CITY OF SOUTHGATE PLANNING COMMISSION AGENDA

Special Condition and Site Plan Review

ACTION REQUESTED: Special Condition/Site Plan Review

2 TRASH ENCLOSURE PLAN
3/8" = 1'-0"

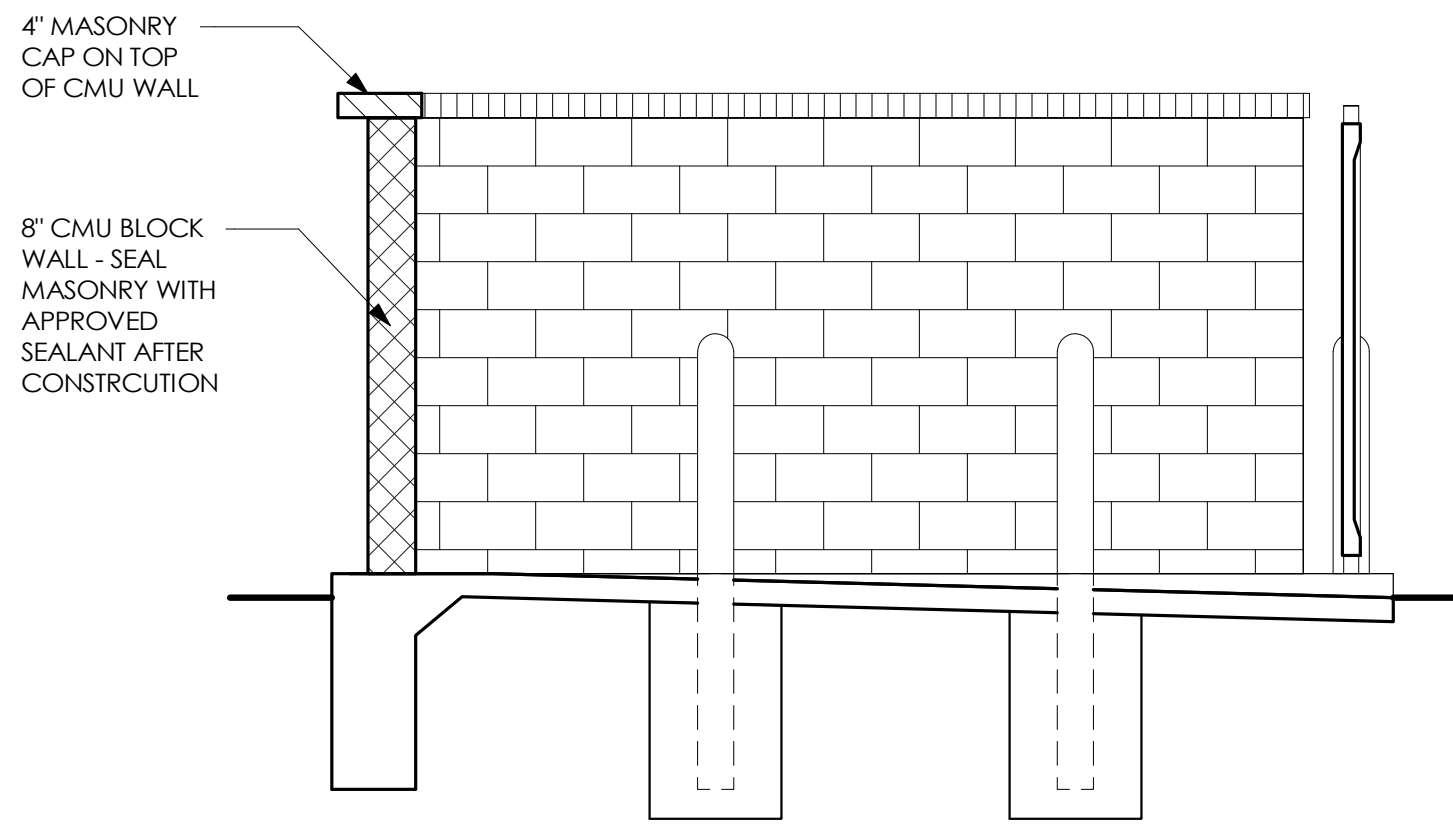
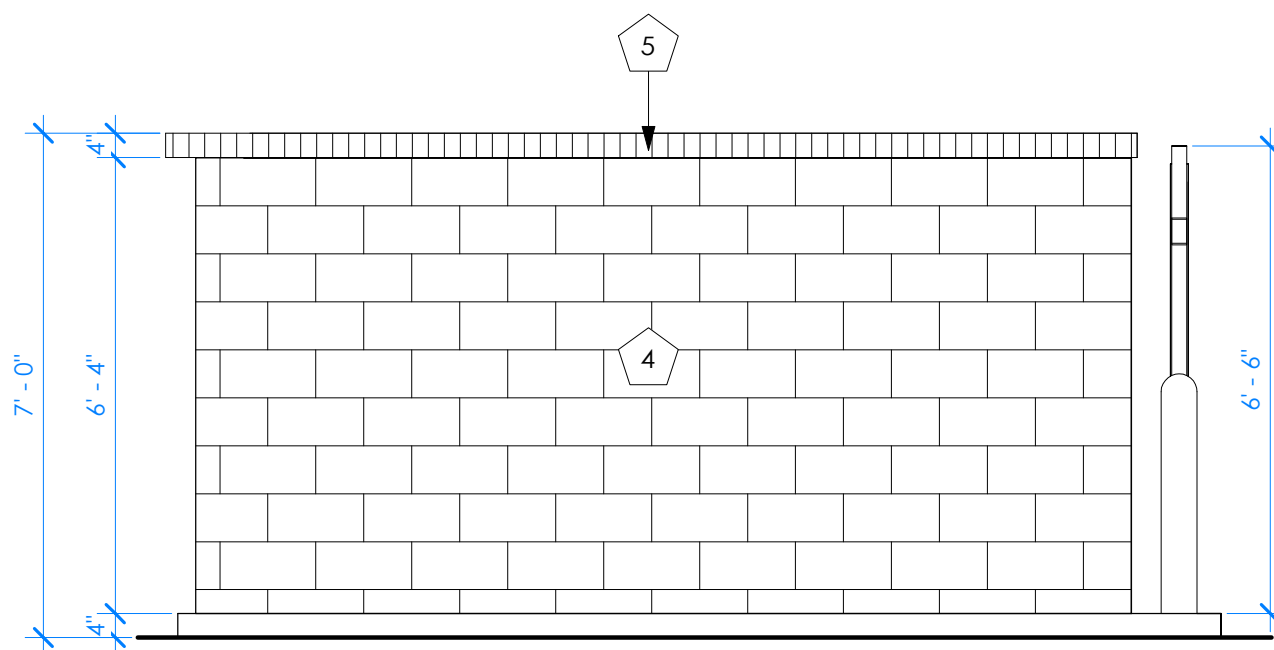
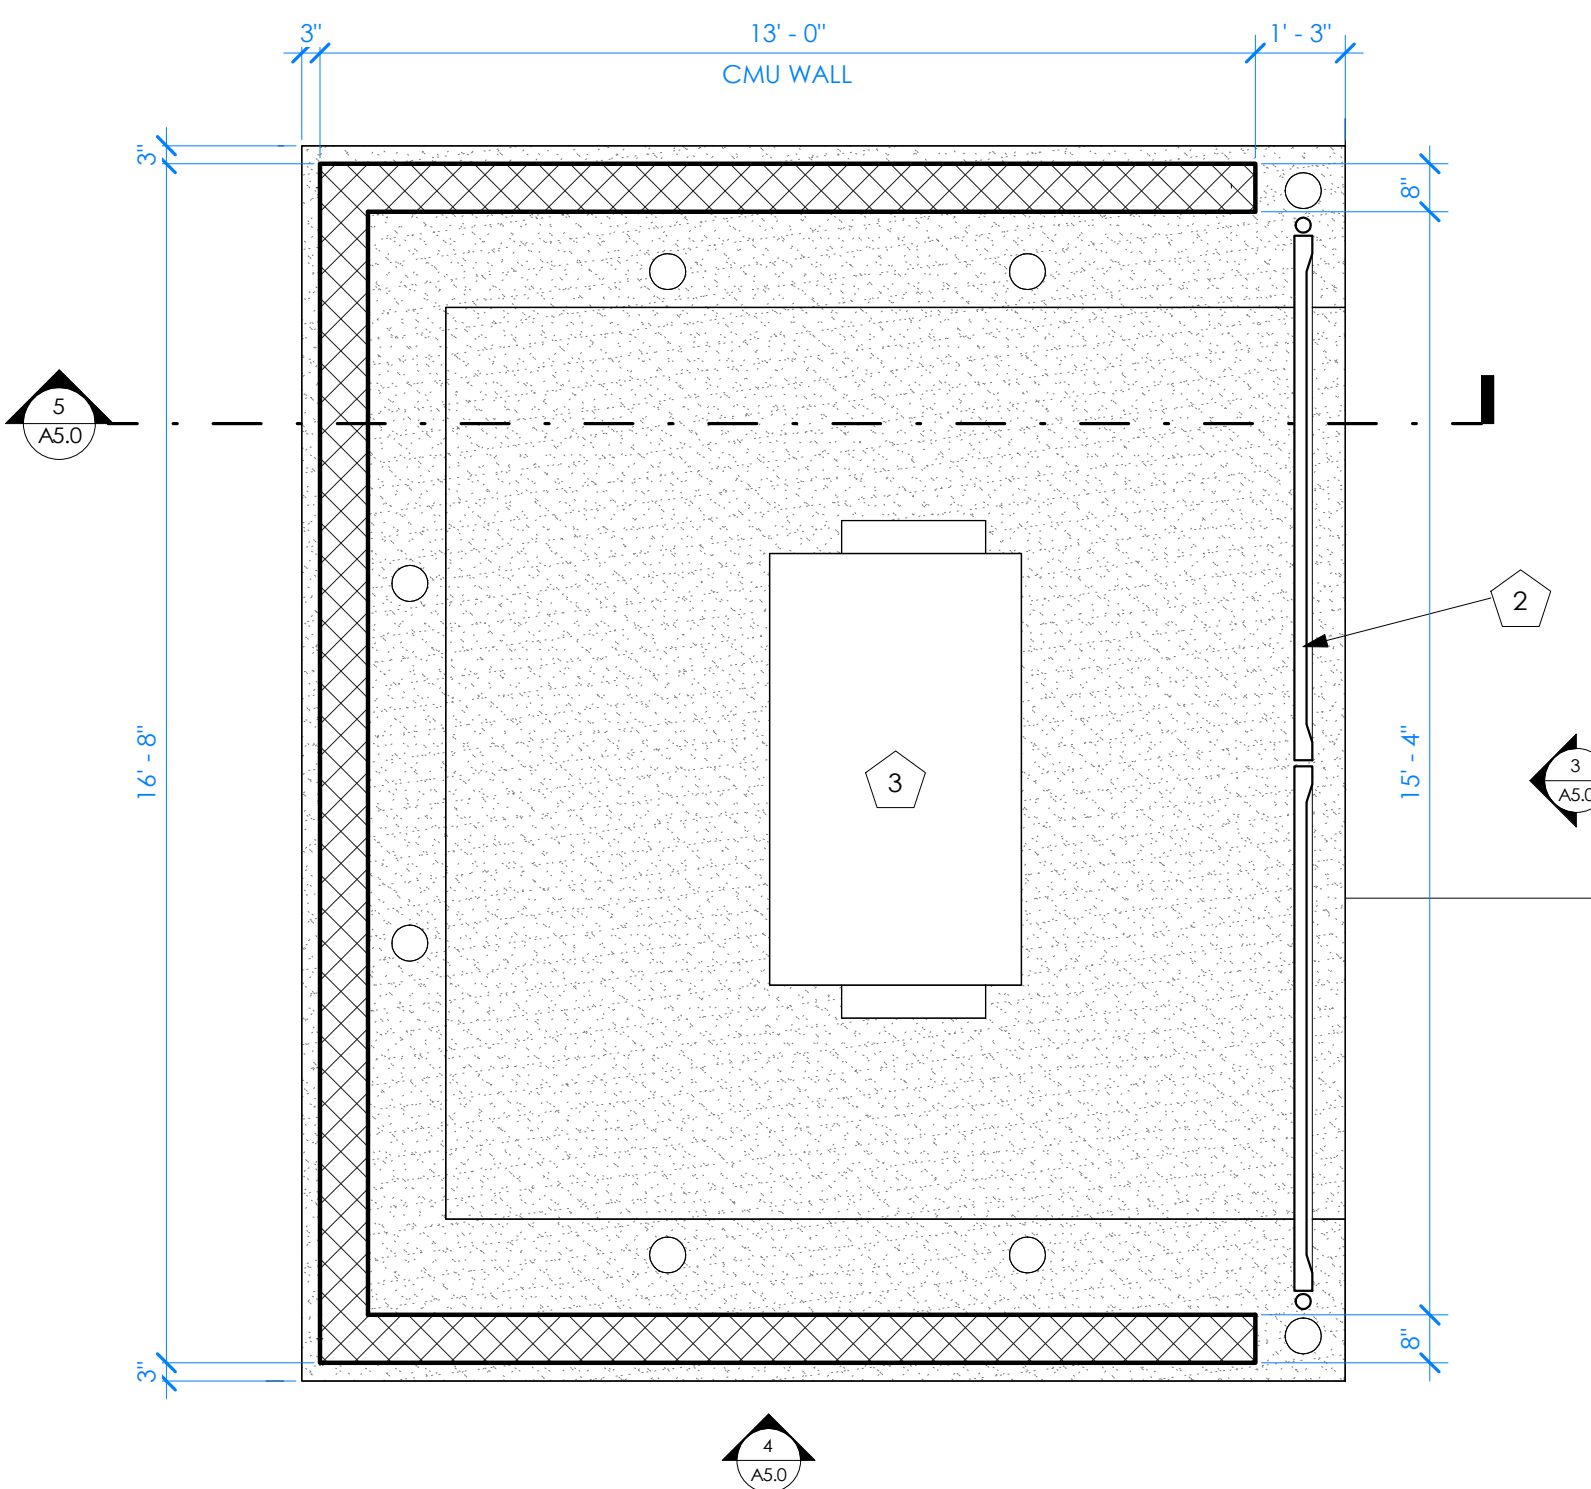
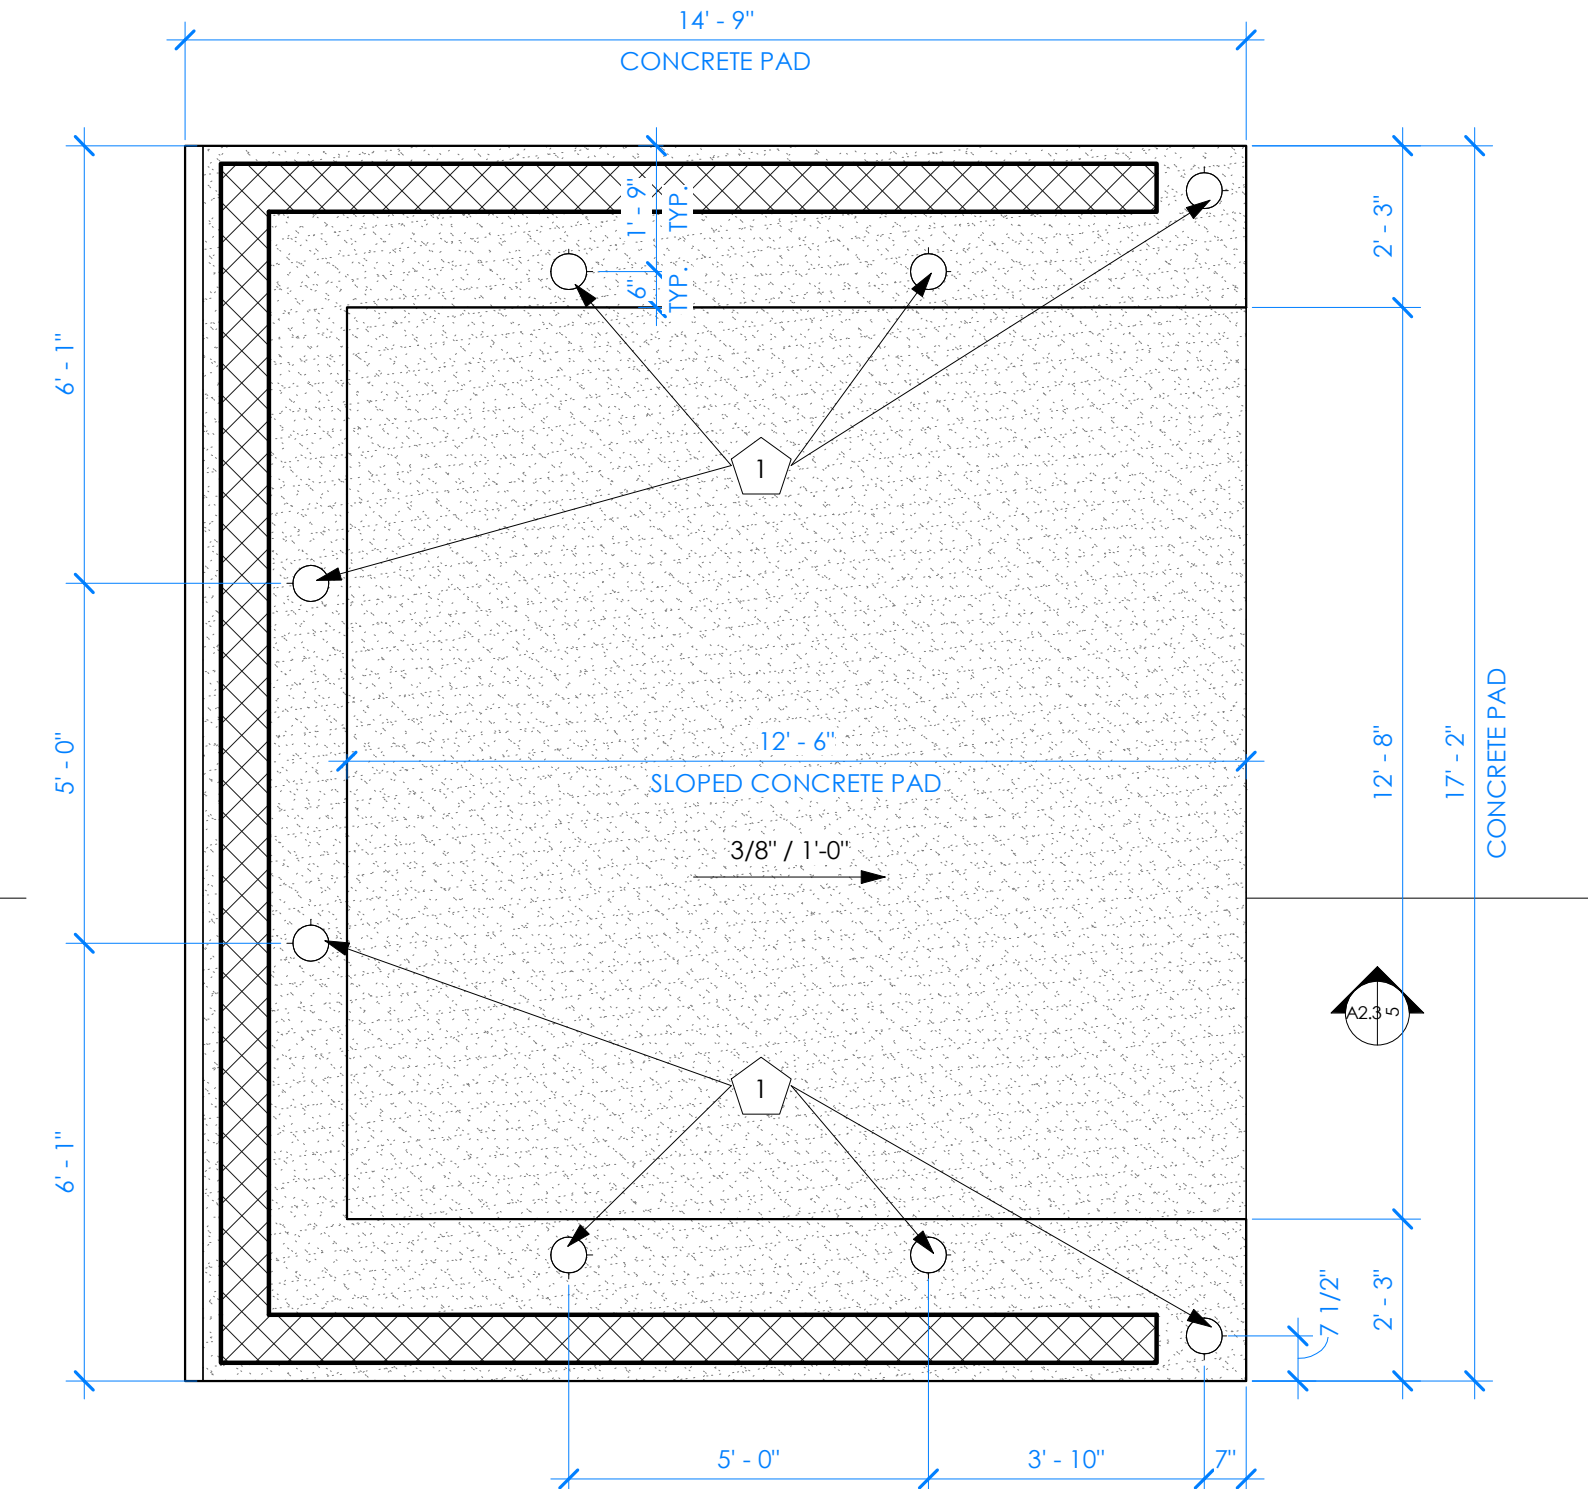
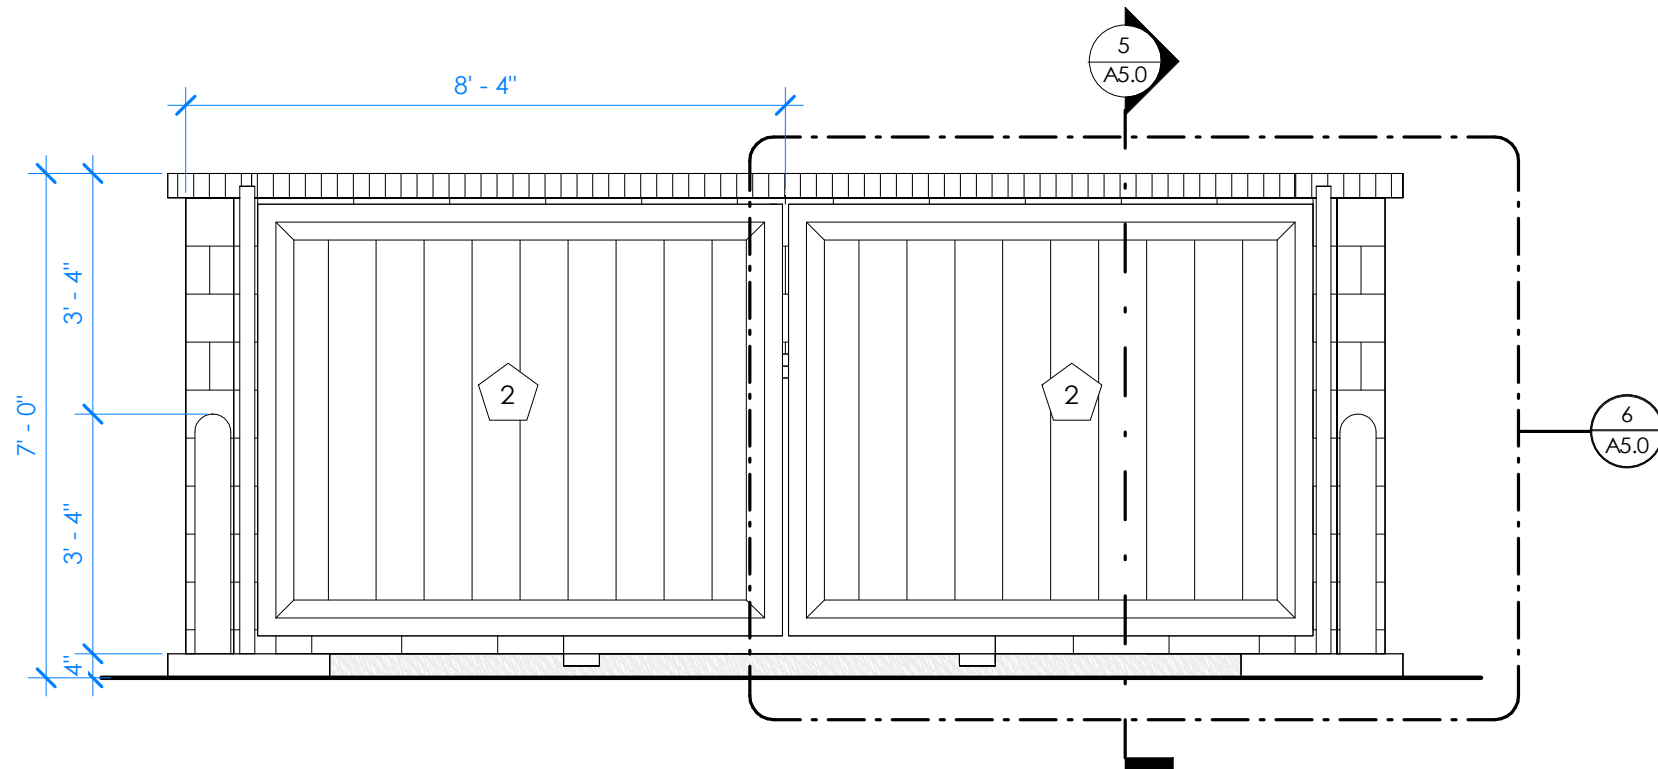
Waste/Dumpster Enclosure: A dumpster enclosure is proposed on the northwest corner of the site. Landscaping in addition to a masonry enclosure is shown on plan, with details are provided on sheet A5.0, showing a height of six and a half (6 ½) feet holding one (1) 8-yard container.
